**Economic Commission for Europe****Inland Transport Committee****Working Party on Intermodal Transport and Logistics****Sixty-fifth session**

Geneva, 19–21 October 2022

**Code of Practice for Packing of Cargo Transport Units****Code of Practice for Packing Cargo Transport Units – text prioritized in updates: blocking material and arrangements, dunnage bags****Note by the secretariat****I. Introduction**

Figure 7.3 Centre gap with transverse ~~bracing~~ blocking

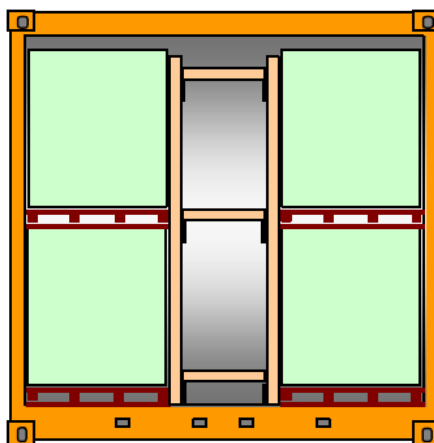
2.3.1 Blocking, ~~bracing or shoring~~ is a securing method, where **either the cargo is stowed directly against strong structural elements of the CTU or additional materials**, e.g., timber beams and frames, empty pallets or dunnage bags **are used to filled in the gaps**

between the cargo and solid boundaries of the CTU or ~~into~~ gaps between different packages (see figure 7.3). Forces are transferred in this method by compression with minimal deformation. ~~Inclined bracing or shoring arrangements bear the risk of bursting open under load and should therefore be properly designed.~~ In CTUs with strong sides, **and where possible**, packages should be stowed tightly to the boundaries of the CTU on both sides, leaving the remaining gap in the middle. This reduces the forces to the ~~bracing~~ **blocking** arrangement, because lateral g-forces from only one side will need to be transferred at a time.

Figure 7.4 Components of a temporary wooden blocking arrangement

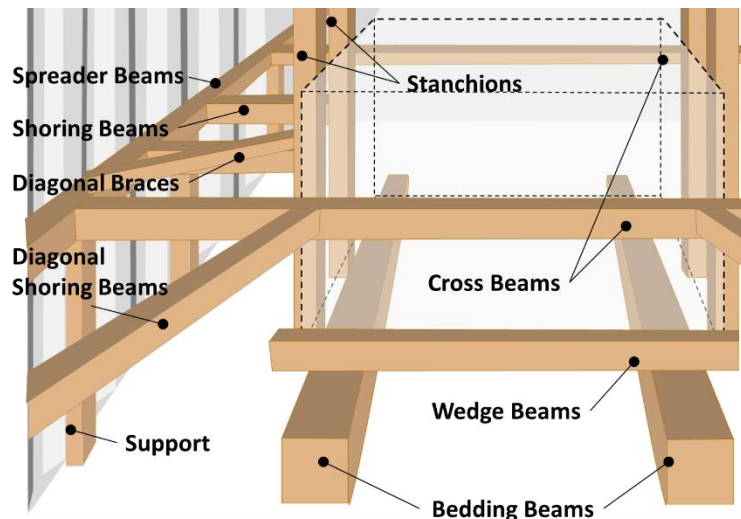
~~2.3.4 A bracing or shoring arrangement~~ **temporary wooden structure** should be designed and completed in such a way that it remains intact and in place, also if compression is temporarily lost. This requires suitable ~~uprights~~ **supports** or benches supporting the actual ~~shores~~ **blocking elements**, a proper joining of the elements by nails or clamps and the stabilising of the arrangement by diagonal braces as appropriate (see figures 7.4 ~~and~~ 7.5). **Inclined blocking arrangements bear the risk of bursting open under load and should therefore be properly designed.**

- Shoring beams are generally under compression
- Spreader and bedding beams run longitudinally
- Stanchions stand vertically
- Cross beams and door shoring bars run transversally

Figure 7.75 Properly cut and nailed wedges

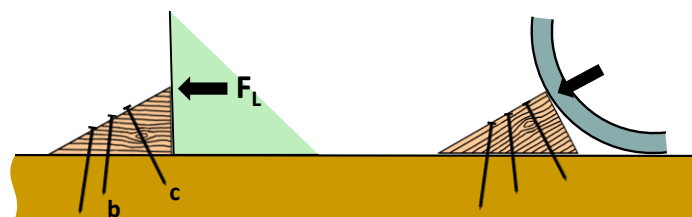
2.3.5 Blocking by nailed-on scantlings that is secured using mechanical fastenings on bedding or spreader beams should be used for minor securing demands only. **The different types of fixing will provide a range of shear strength, depending on the type, configuration and size of the nails fastener used. For example, the shear strength of such a blocking arrangement secured using nails may be estimated to take up a blocking force between 1 and 4 kN per nail.** Nailed-on wedges may be favourable for blocking round shapes like pipes. Care should be taken that wedges are cut in a way that the direction of grain supports the shear strength of the wedge. Any such timber beams or wedges should only be nailed to bedding beams or timbers placed under the cargo (see figure 7.5). Wooden floors of closed CTUs are generally not suitable for nailing. Nailing to the softwood flooring of flatracks or platforms and open CTUs may be acceptable with the consent of the CTU operator (see figure 7.7).

Figure 7.6 Withdrawal loads

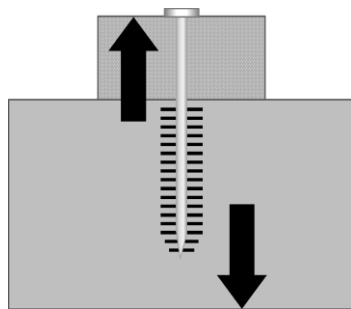
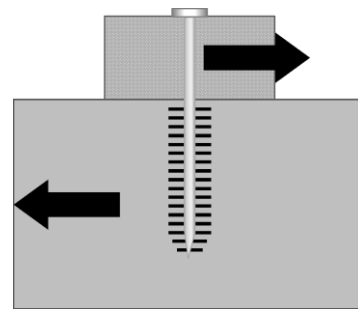
1. Nails in use are subjected either to withdrawal loads or lateral loads (as shown in figures 7.6 and 7.7), or a combination of the two. Both withdrawal load and lateral load are affected by the wood, the nail, and the condition of use.

Figure 7.8 Lateral displacement and effect on nail

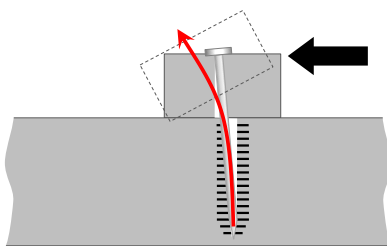
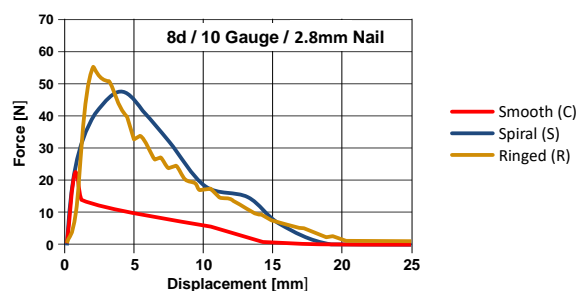
2. Any lateral load on a blocking element that is affixed using nails will result in the hole formed in the timber as the nail is driven in will distort and the blocking element rotates, thus levering out the nail (see figure 7.8). As shown in Figure 7.9, the force required to extract the nail diminishes significantly already at relatively small displacements, but the effect is less prominent for ringed or spiral nails.

Figure 7.10 Depth of penetration

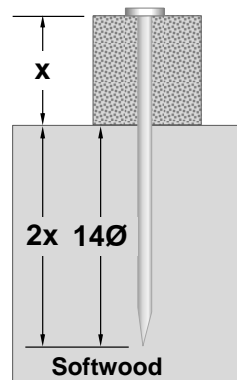
1. The lateral nail load is also related to the depth of penetration of the nail in the foundation member or member receiving the point. There are two general rules for the depth of penetration:

(a) The depth of penetration generally recommended for plain-shank nails to develop full load varies but is about 14 times the nail diameter for the softer woods<sup>1</sup>.

Figure 7.40 Boundary blocking arrangement

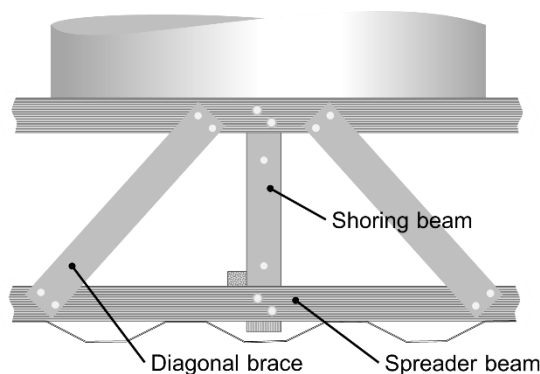
**4.1.7.2 Additional shoring may be made against the boundary side and front walls so long as the forces are distributed by spreader beams as shown in Figure 7.40 and Figure 7.41**

Figure 7.2942 Packing 1,000 x 1,200 mm unit loads into a 20-foot container

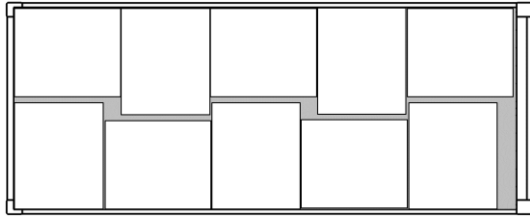
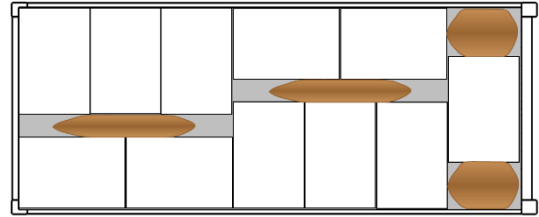
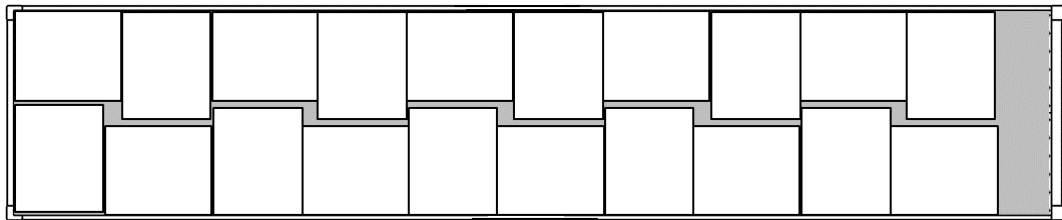
**Note:** The void areas (grey shaded) shown in figures 7.2942 to 7.3144 should be filled when necessary (see **clause subsection 2.3.67** of this annex).

Figure 7.3345 Threshold by height

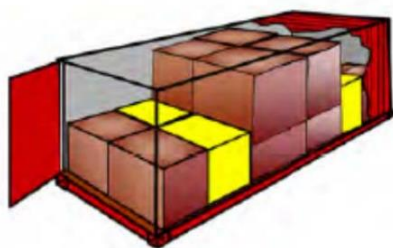
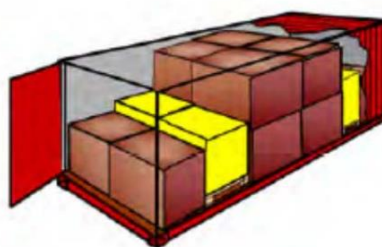
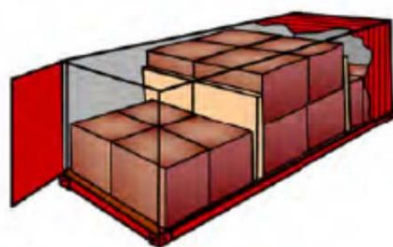
4.23.6 Where there is the need to stack packages in an incomplete second layer at the centre of the CTU, additional longitudinal blocking can be adopted (see figures 7.3345 to 7.3648).

Figure 7.51 Wooden structure for blocking against the end wall of flat rack

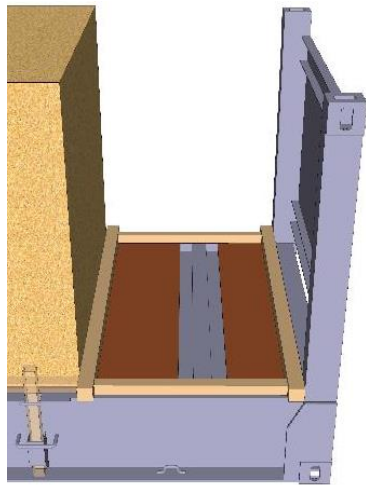
**4.3.8** When a temporary wooden structure is used to block the cargo against the end walls of platform and flatrack type CTUs, this should be supported against the corner posts and the shoring beams should be placed as far out towards the sides as the cargo permits (see figure 7.51). Stanchions, produced from wooden beams with a cross section of 75x75 mm, may often be inserted into pockets along the sides of the platforms to prevent the cargo from sliding sideways (see figure 7.52).
